# Addendum/Addenda

No./N° 4
-------------

Project Description / Description de projet  M-38 Flexible Research Facility		
Solicitation No./ N° de sollicitation  16-22072	Project No./N° de projet  5044-M38	W.O. No./N° d'ordre de travail
Departmental Representative / représentant ministériel  Allan Smith	Date  2016 Sep 20	
<b>Notice:</b> This addendum shall form part of the tender documents and all conditions shall apply and be read in conjunction with the original plans and specifications.		<b>Nota:</b> Cet addenda fait partie intégrale des dossiers d'appel d'offres; toutes les conditions énoncées doivent être lues et appliquées en conjonction avec les plans et les devis originaux.

dwg no. **5049-S01** dessin no.

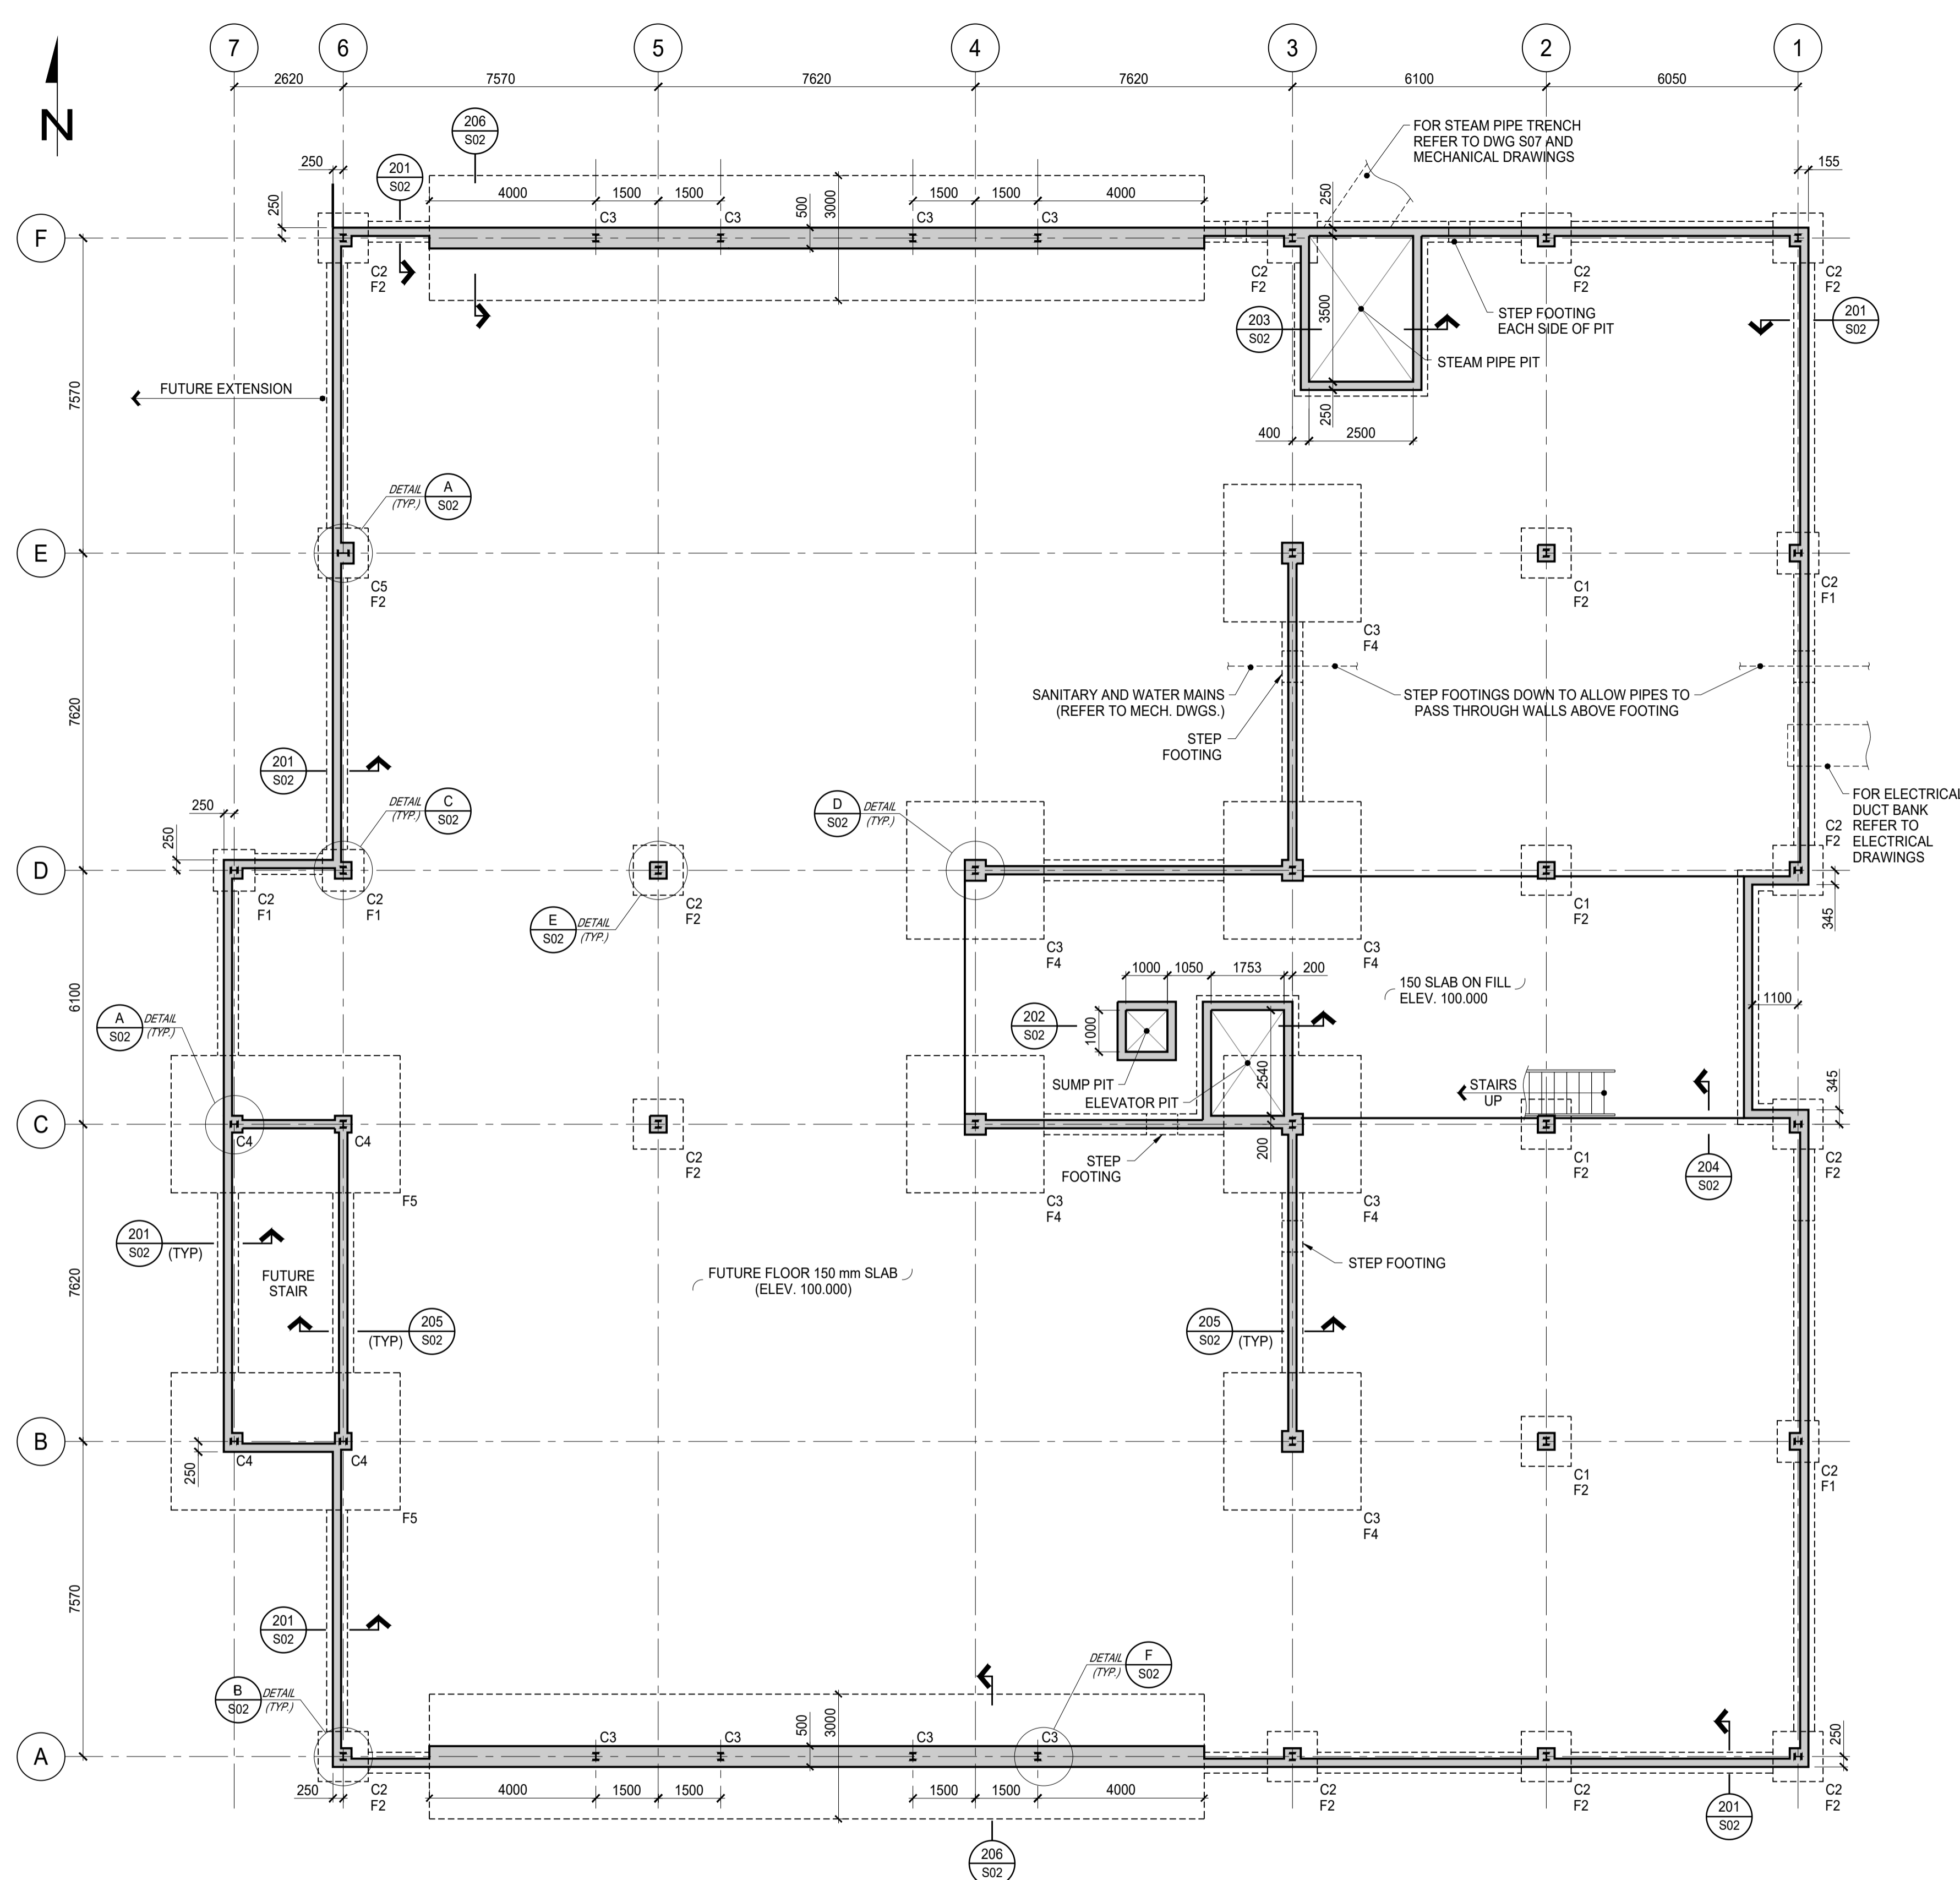
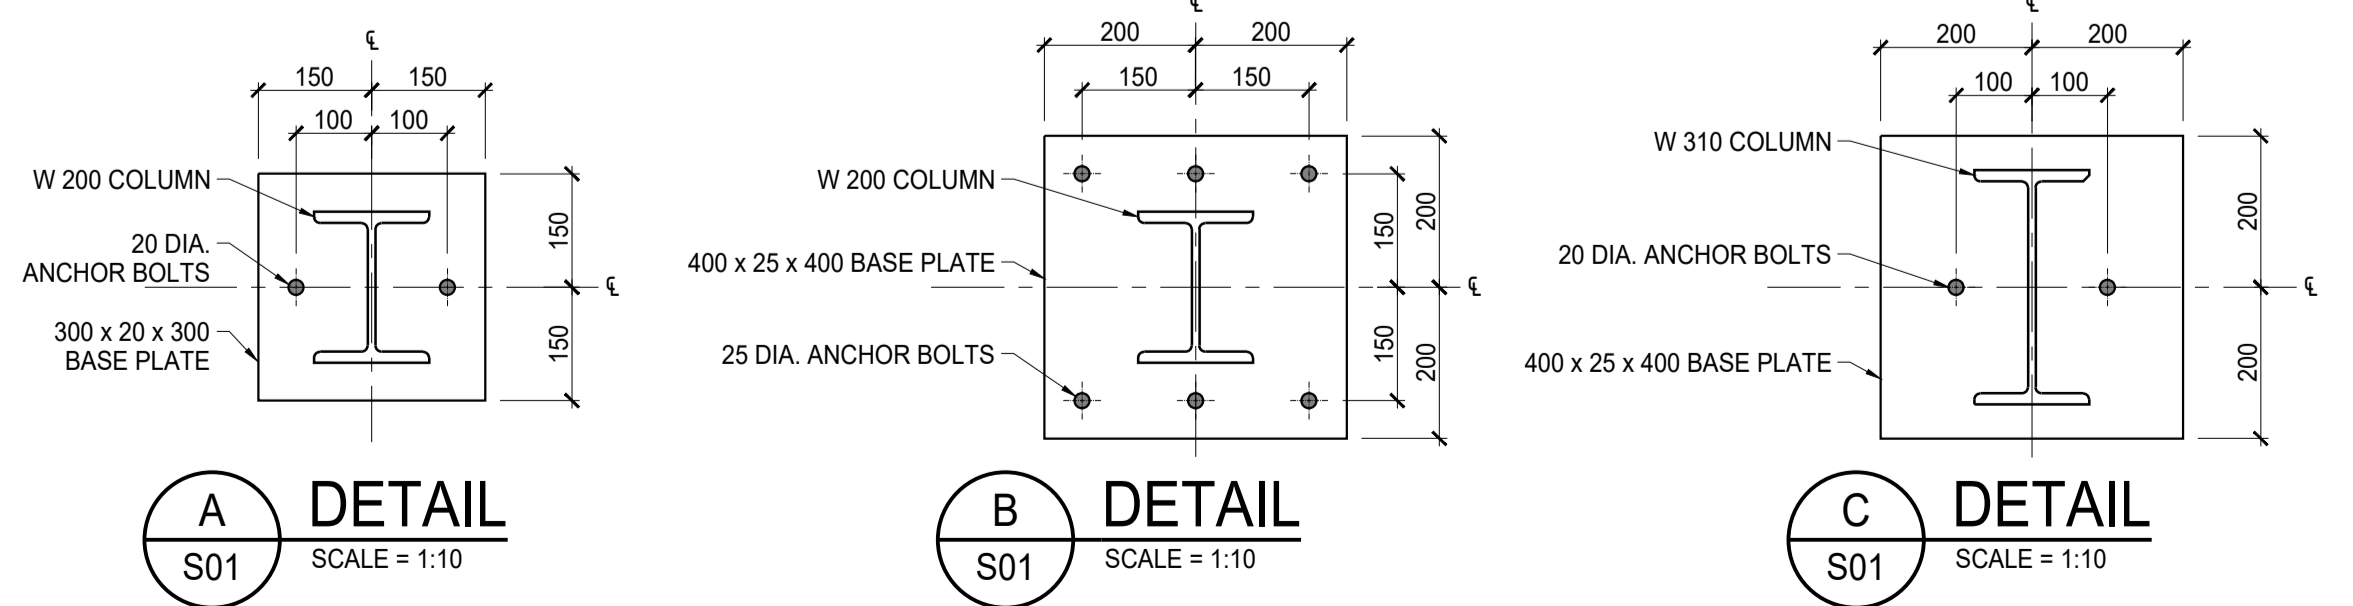
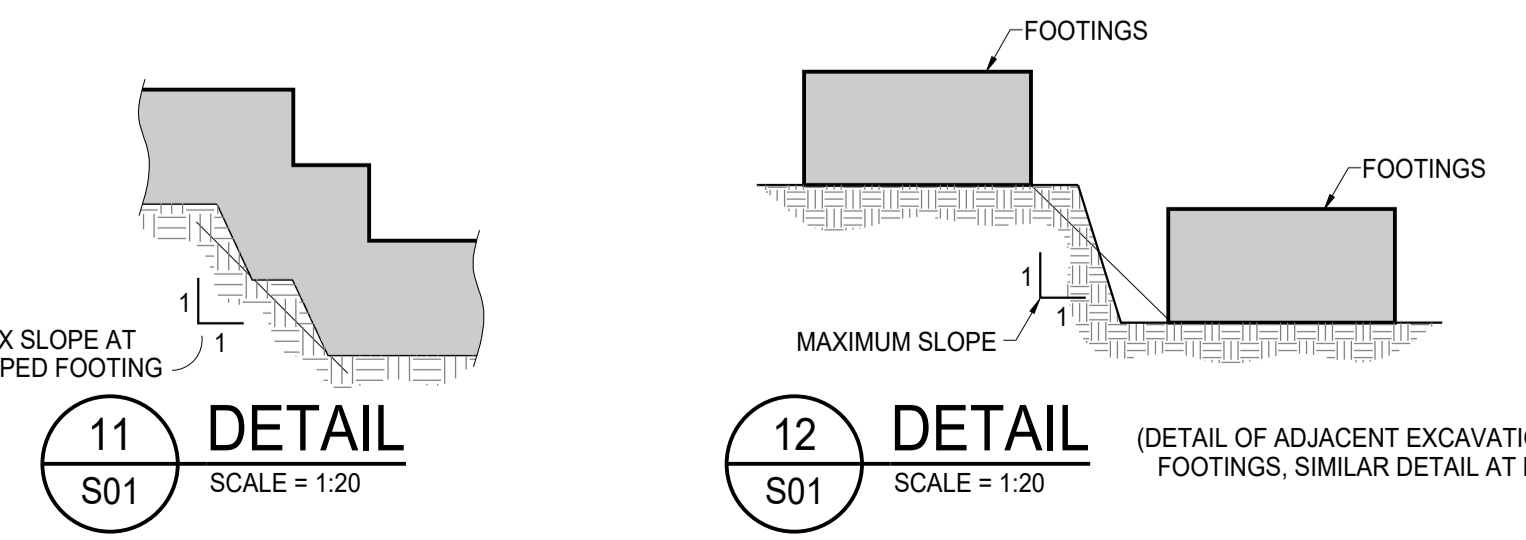
18. Q According to the footing schedule noted on drawing S01 we are to provide an 'F3' type footing however, upon review of the structural drawings there appears to be no such type of footing. Is 'F3' required?  
A **The 'F3' footing is no longer required.**

21. Q Dwg S01 - Should there be stepped footings between the F4 footing at grid C3, and the two adjoining F4 footings at grids C4 and B3?  
A **Stepped footings shall be provided in accordance with the General Notes on the revised structural drawing S01, which is attached to addendum no. 4.**

**2**  
A05 ELEVATION  
SCALE = 1:100

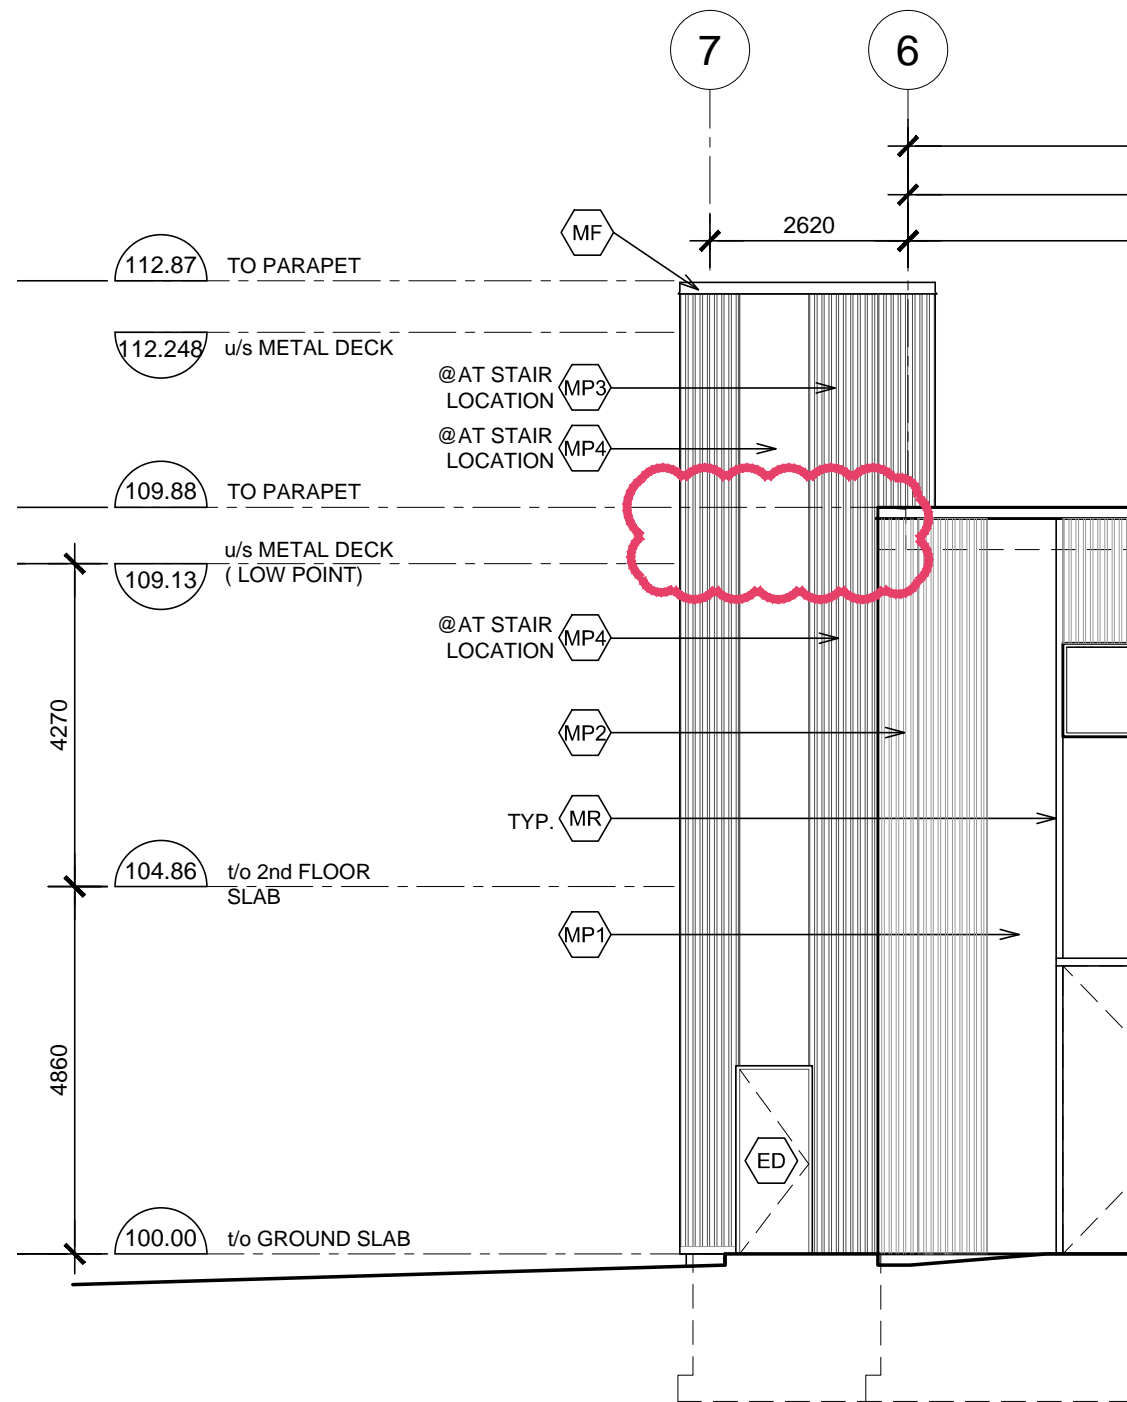
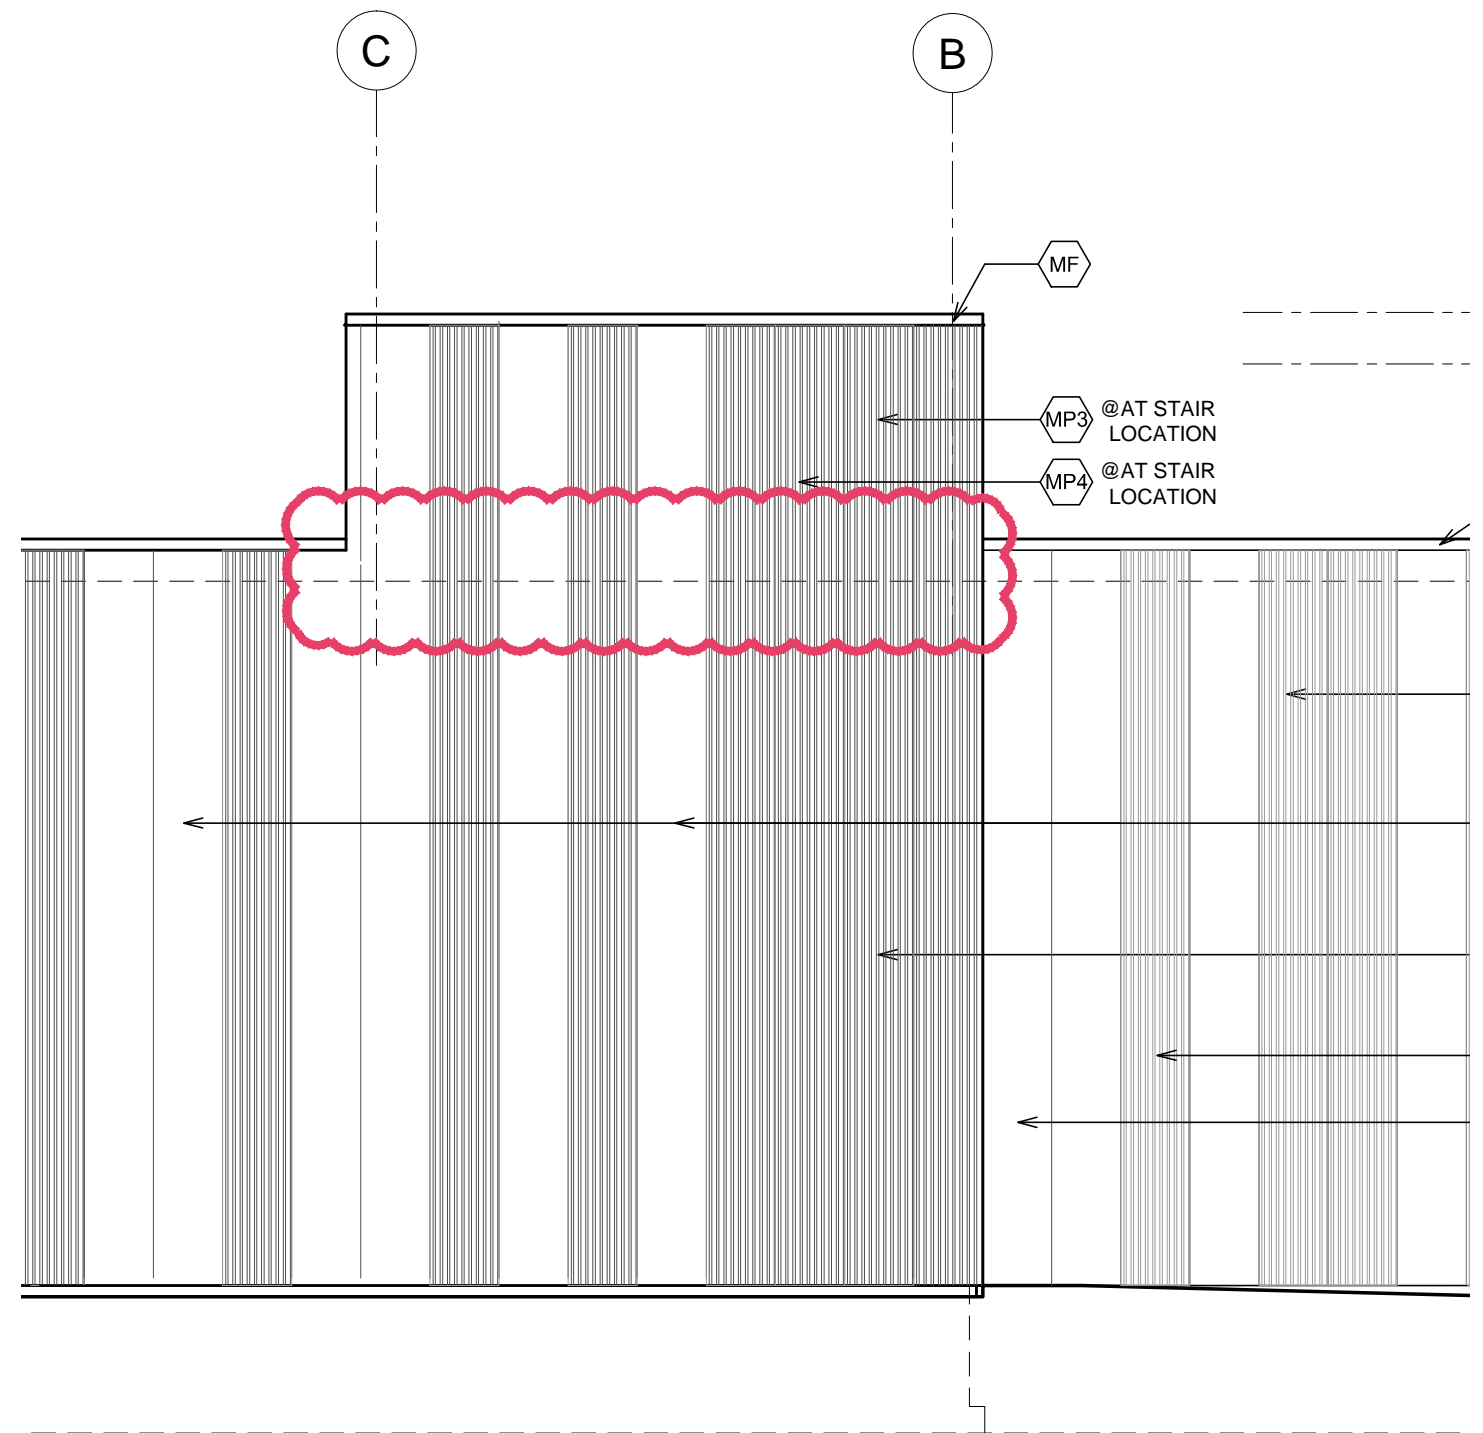
1. **Reference drawing 5044-A00 - Cover**
  - .1 Revise all type W3 to read 13mm FIBER REINFORCED CEMENT BOARD PANEL TO **600mm** BELOW GRADE
2. **Reference drawing 5044-A05 & A05a – Building Elevations**
  - .2 Revise elevation to remove horizontal reveal. No horizontal reveal is required Refer to revised elevations 2/A05 and 1 A05a on attached ASK-01.
3. **Reference drawing 5044-A05– Building Elevations**
  - .3 Revise elevations 1 and 2/A05. Remove all vertical reveals as indicated by elevation tag “MR”. Horizontal reveal to remain as per elevation tag “MR”.
4. **Reference drawing 5044-2/A05 – Building Elevations**
  - .4 Revise elevation TAG for center overhead door from **FD** to **OD**.
